TELECOMMUNICATIONS  
F 377 Mod Instr No 1

WIRELESS SET NO 31AFV

TECHNICAL HANDBOOK - MODIFICATION INSTRUCTION.

Rebroadcast facility failure, Wireless set No 31AFV/Wireless set No 19

Fig 1 - Modification to PS and LF amplifier unit No 3

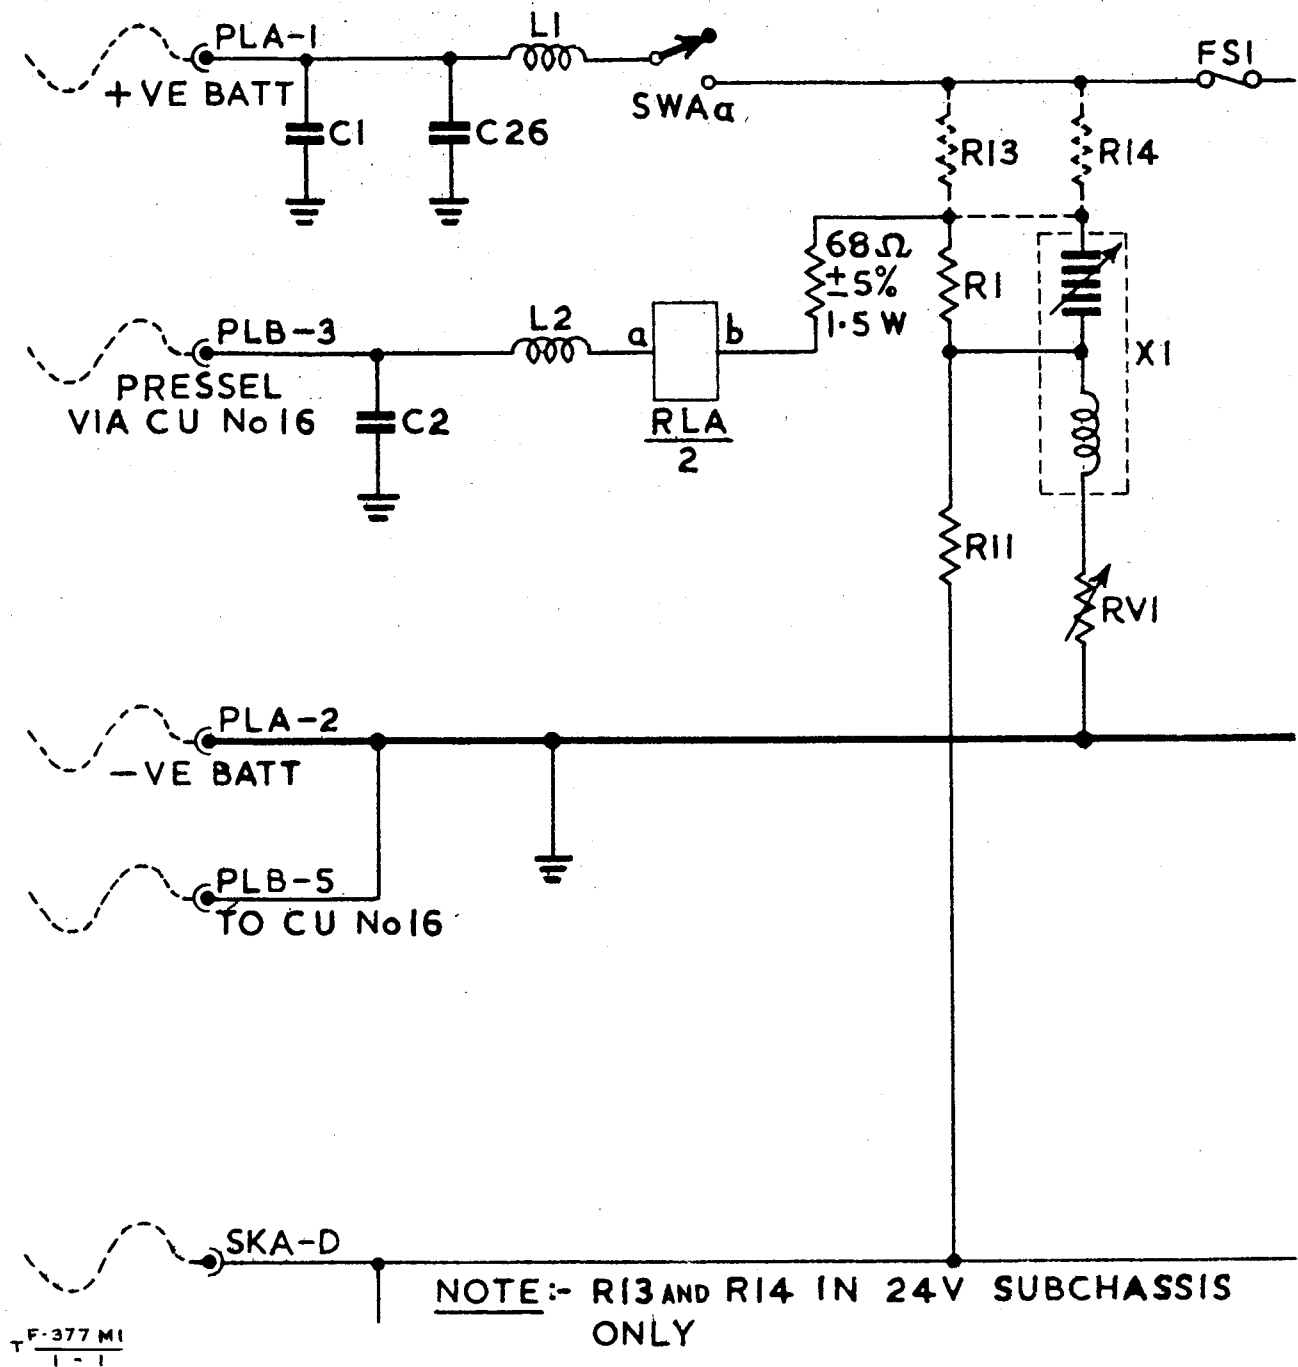
1. When the Wireless set, No 19 and Wireless set, No 31AFV, are connected via Control units, No 16 or No 17, the facility for operating both sets simultaneously cannot be effected. With the circuits as at present (Tels F 372 page 1010, Fig 1002, issue 1, 24 Nov 53 refers) the A-set is held in the 'send' position when the Control unit, No 16, is switched to position 'A and 31'. This is due to the present method of energising relay  $\frac{RLA}{2}$  in the Power supply and LF amplifier unit No 3. This instruction details a circuit change in the PS and LF amplifier unit No 3 to correct this fault in operation.

6. (a) Remove the PS and LF amplifier unit from its case and turn it upside-down.
- (b) Locate resistor R11 ( $3\Omega$   $\pm 5\%$ , wirewound).
- (c) Remove the red lead joining R11 to the tagboard above relay RAA  
2
- (d) Connect a length of PVC-insulated wire between the tagboard connection in (c) above and the nearest spare tag on the tagboard situated just above transformer TR3 (IC input transformer).
- (e) Connect the  $68\Omega$  resistor (Z 243340) between the spare tag referred to in (d) above and a further spare tag on the same board.

(Note: It is important that the connections should be made to the tag-ends furthest from the baseplate, thus avoiding possible short-circuits to the case)

- (f) Connect a length of PVC-insulated wire between the open end of the  $68\Omega$  resistor and the tag of the carbon pile marked XI, (to which a green wire is already connected).
